UNITED STATES PATENT AND TRADEMARK OFFICE

APPLICATION NO.	FILING DATE	FIRST NAMED INVENTOR	ATTORNEY DOCKET NO.	CONFIRMATION NO.
09/145,982	09/03/1998	TOMOHARU HASE	684.2728	6632

Office Action Summary	Application No.	Applicant(s)	
	09/145,982	HASE, TOMOHARU	
	Examiner	Art Unit	
	Hung Henry V Nguyen	2851

Fig.7 of Tanimoto

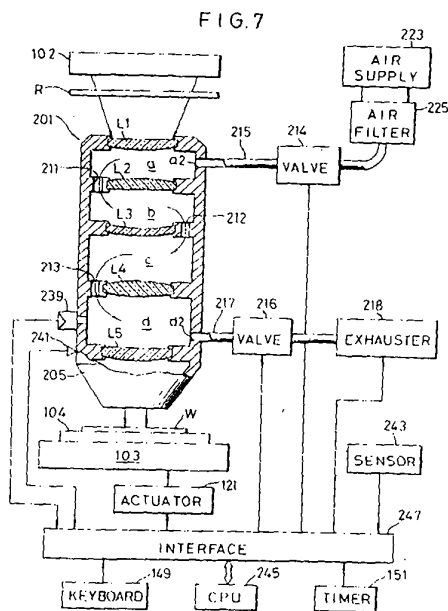
With respect to claims 36-41, 44-46, 57-62 and 65-67, Tanimoto et al (fig.7) discloses an exposure apparatus comprising all basic features of the instant claims including: an optical system (201) having at least one optical element (L1-L5) and including a supporting portion (205) for supporting at least one optical element and having a plurality of apertures (211-213) through which a gas can flow; an illumination optical system (102) for illuminating a reticle (R) and a gas supply (223); the optical system comprises a plurality of spaces (a-d) where the apertures of the two adjacent two lenses are placed "at rotational positions, about an optical axis of the optical system, with angle other than zero degree and 180 degrees"/ or "the a straight line connecting apertures of the adjacent two separating portions is not parallel to any of the optical axes /or is not contain in any of planes including optical axes of the optical elements of the adjacent two separating portion (as clearly illustrated from fig.7).

8. Applicants' amendments filed September 2, 2003 have been entered. Applicant's arguments with respect to prior art rejection have been carefully reviewed but they are not found persuasive. Based on figure 7 of Tanimoto, Applicant argues that while Tanimoto teaches air holes (for example: 211, 212) between adjacent optical element spaces are located 180 degrees apart, claims 37 and 57 of the present applicant, call for "with angles other than zero degree and 180 degrees"; the Examiner respectfully disagrees with the applicant. Firstly, the amended claims 36 and 57 are rejected under 35 U.S.C. first and second paragraphs as set forth above. Secondly, the Applicant can not rely on the drawing of Tanimoto to support his/her position since the drawings in a patent need not be drawn to scale. Unless otherwise stated, there is no evidence, or any statements in reference of Tanimoto, other than applicant's arguments, which suggest that apertures (211, 212) are disposed at 180 degrees difference. Also, it is the Examiner's position that the difference would be met by manufacturing tolerance and/or defect. Would having a very small angular difference, such as 0.000001 degrees between the air hole 212 and the air hole 213, achieve the claimed results? Yes, since such angular difference would be very common in manufacturing. Finally, Applicant argues that a straight line between air holes 211 and 212 and a straight line between air holes 212 and 213 are not parallel to the optical axis of the optical system, these straight lines therefore intersect the optical axis of lens L2; the Examiner disagrees with the Applicant since this is not quite true. One having ordinary skill in the art would recognize that the straight lines between air holes 212 and 213 and the straight line between hole 211 and 212 do intersect with a plane that contains the optical axis of the optical

system but these straight lines may not intersect with the optical axis of the optical elements.

Therefore, Tanimoto meets all of the limitations of the instant claims.

Fig.7 of present application

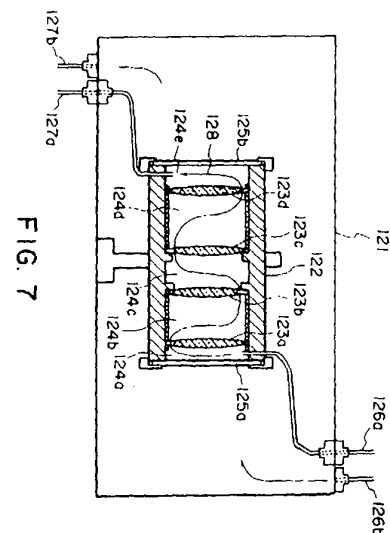
As to claims 36 and 57, the specification of the disclosure lacks adequate support for the claimed provision of "wherein apertures of the adjacent...with an angle other than zero degree and 180 degrees". Applicant is reminded that when claimed elements that are not fully discussed in detail, this falls under 112, first paragraph, applicant's disclosure is lacking in this aspect. The remotest relevancy to the claimed subject matter may be figure 7 and in the statement of "a straight line connecting the passages 32 of adjacent lens supports 31 is out of

parallel to an optical axis of the lens 30” (see page 14, line 14 to page 15, line 6). However, it is the Examiner’s position that this statement and figure 7 (or figure 2) fail in any manner to teach the claimed limitation of apertures of adjacent separating portions being rotated from one another at other than zero or 180 degrees. If the Applicant does not agree with the Examiner, the Examiner respectfully submits that Applicant points out clearly supporting evidences that the instant specification supports the subject matter which applicant regards as the invention. Comparing figure 7 of instant disclosure and figure 7 of Tanimoto et al’ 4,690,528, the Examiner fails to find any differences.
